DEVELOPMENT ASSESSMENT REPORT

Reporting Officer:	Malcolm Ryan - Director Strategic and Development Services for Warringah Council
Address / Property Description:	Lot 1 in DP 1136022, No. 2 Mooramba Road, Dee Why; and Lot 2 in DP 1136022, No. 10 Painters Parade, Dee Why
Development Application No:	DA2010/1839
Description of Development:	Demolition works and construction of residential flat buildings and associated basement car park including landscape/site works
Application Lodged:	08/11/2010
Plans Reference:	DA06, DA11, DA12,DA13, DA14,DA15, DA16,DA17, DA20,DA21, DA30, DA31, DA35, DA36, DA40, DA41, DA50,DA55, DA70, 10-074 L01(F), 10-074 L02(D),10-074 L03(D), 10-074 L04(D), HDA01/P2, HDA02/P2, HDA03/P2, HDA04/P2, HDA05/P2,
Amended Plans:	10-074 L01(G), 10-074 L02(E), 10-074 L03(E), 10-074 L04(E), HDA01/P3, HDA02/P3, HDA03/P3, HDA04/P3, HDA05/P3, HDA06/P1
Applicant:	Dee Why Property Development Pty Ltd
Owner:	Dee Why Property Development Pty Ltd

Lot 1 in DP 1136022, No. 2 Mooramba Road, Dee Why; and
Lot 2 in DP 1136022, No. 10 Painters Parade, Dee Why

Modified by the author from Plan No. DA41 – Sections D-D + E-E by JAA Studio
Note: The lower red line indicates the extrapolated natural ground level.

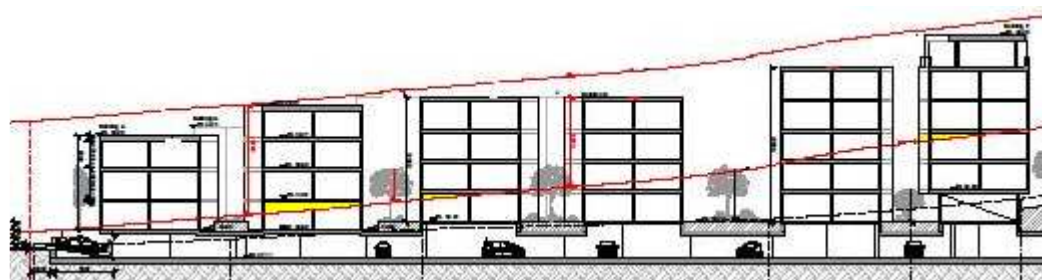
Standard	Permitted	Proposed	Compliant
Building Height (storeys)	3 storeys	3 - 4 storeys	No (partial)

The development breaches the Control in Buildings B, C and F which results in a technical non-compliance of one (1) additional storey (the non-compliant areas involve a height of 1.0m above natural ground level below the three storey structure thereby counting as an additional storey). The illustration below shows the location of the non-compliance (indicated in yellow).

The development does not adversely impact upon the streetscape of Mooramba Road. Section E-E on Plan No. DA41 (Sections D-D & E-E) reveals that the non-compliance is due to the intersection of the extrapolated natural ground level through a part of the floor immediately below the three storey structure. For this reason, the non-compliance has been identified as an additional storey. Notwithstanding, it is also noted on the Plan that the building height at this point is below 11.0m which is compliant with the Control. This is considered to be a technical non-compliance as the design does not incorporate a consistent non-compliant full storey and would not visually result in an obvious breach should the natural ground level still be in existence.
